IFIB ACT-JWC-21-15
GRAPHICS PRODUCTION SUPPORT SERVICE
WEEK 20 FINAL
Q&A

ANNEX F – FLOOR PLAN

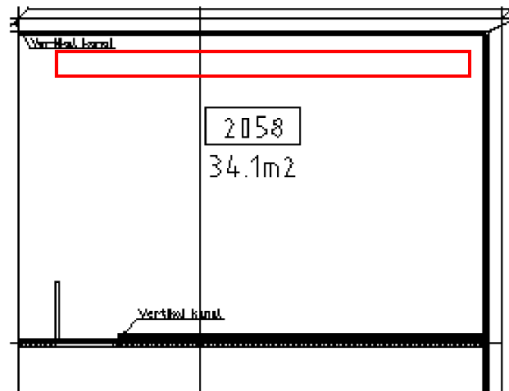
[1Q:](#) Can the printer be installed along this wall? (red marking)

Room 2058 34.1 m² - is the Printer Room.

As shown in Annex E – Pictures of Print room, picture on page 2 and 4, there is a custom made ventilation system on parts of that wall made for the Plotter, binder, laminator and engraver. Therefore unfortunately, it is only possible to install the system where it is not in conflict with the ventilation system.
